Re: **Hines Energy Complex - Power Block 3**
Additional Information Related to
Project No. 1050234-006-AC/Air Permit No. PSD-FL-330 and
Supplemental Site Certification Application to PA 92-33

HINES ENERGY COMPLEX, POWER BLOCK 3
GENERAL, RESIDENTIAL, COMMERCIAL, INDUSTRIAL GROWTH

Re: **Florida Power - Hines Energy Complex
Power Block 3
Supplemental Site Certification Application - PA 92-33SA2
Response to Sufficiency Questions**

FIGURE 1
 MONITORING WELL LOCATIONS

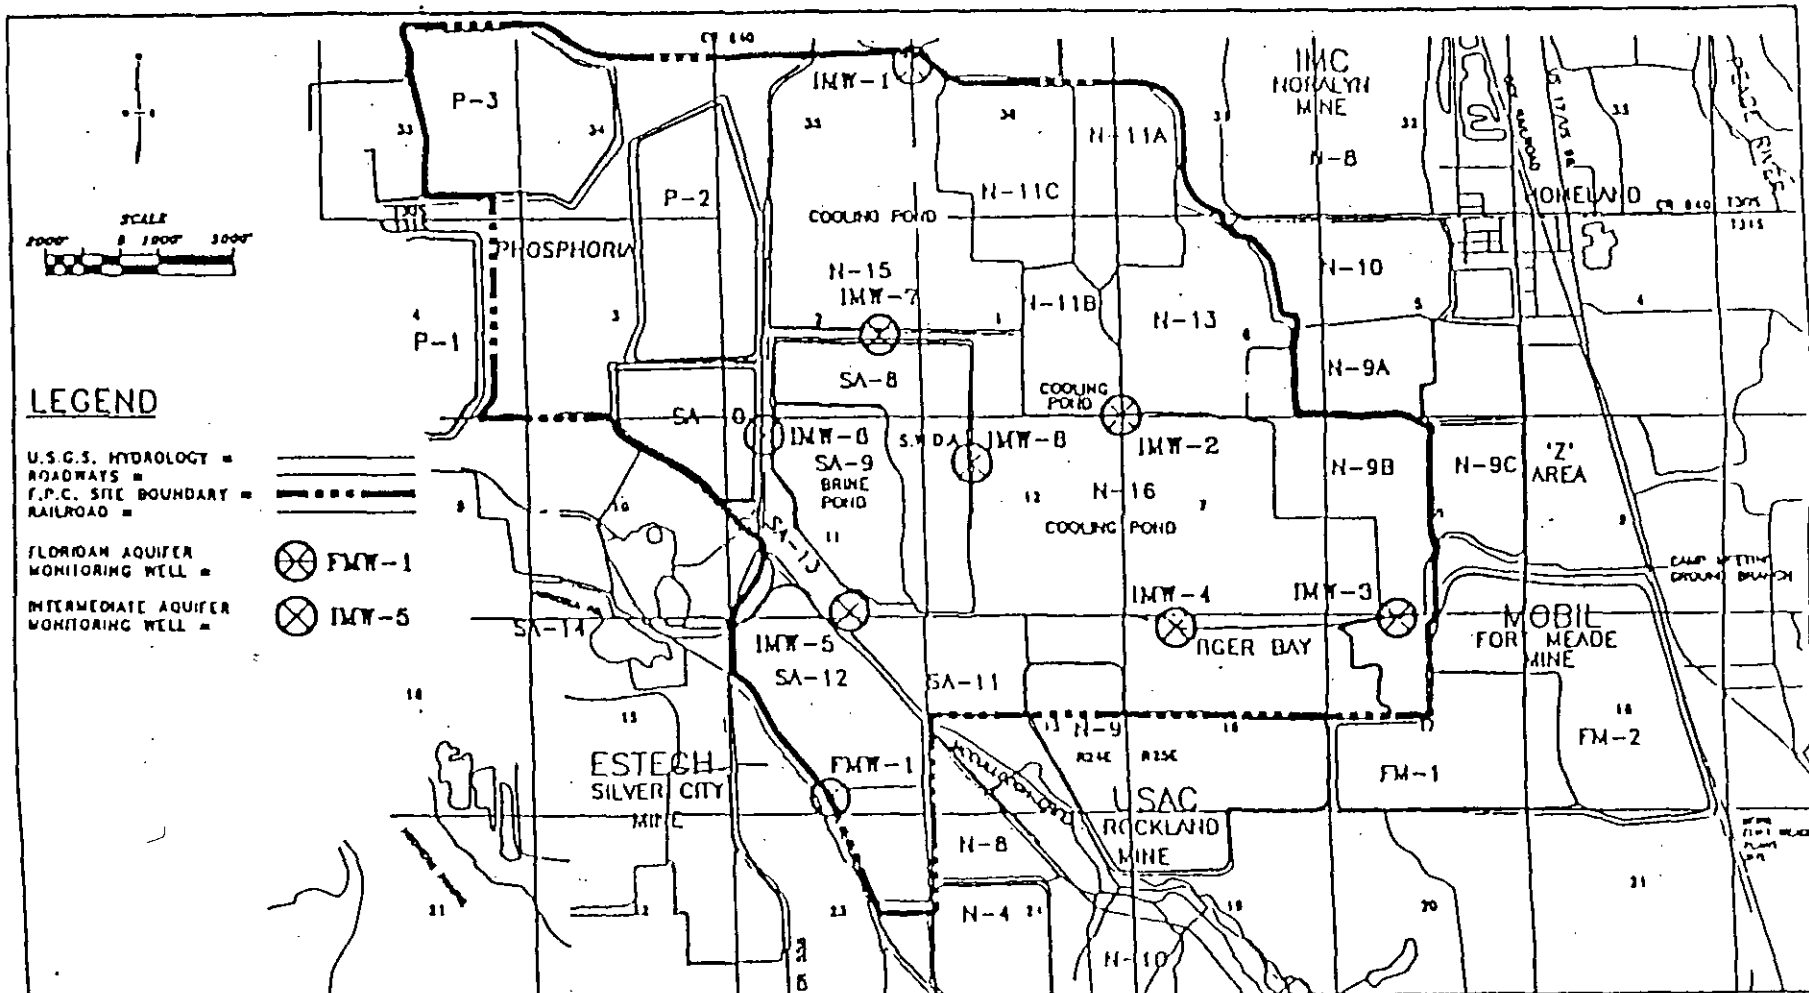
2. Departmental records indicate that the ground water monitoring plan (GWMP) for the facility was implemented in January of 1998, and consists of 7 wells designated IMW-1 through 6 (Intermediate aquifer), and FMW-1 (Floridan aquifer). Watershed Management requests a copy of the post construction GWMP well location map.
